NTK TECHNICAL CERAMICS

TITLE 20 LEAD CHIP CARRIER

DWG NO. IRK20F1-5856B

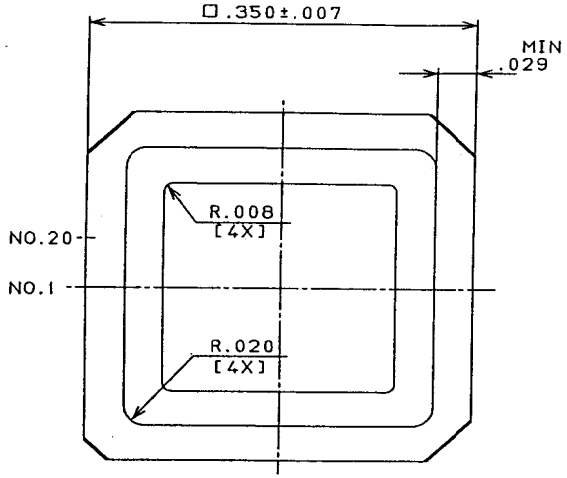
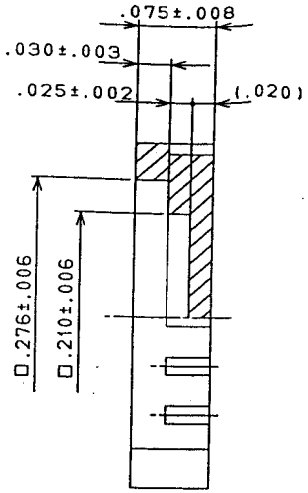
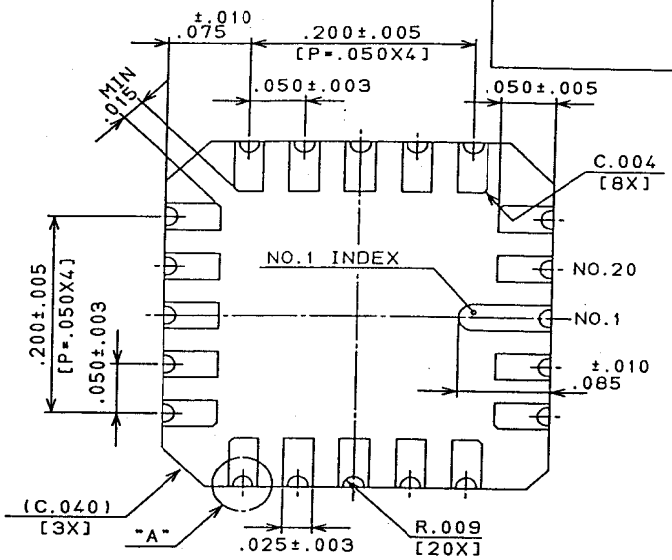
LATEST REVISION'S	DESCRIPTION
A	CHG TOP CAVITY TOL ±.006 WAS ±.008
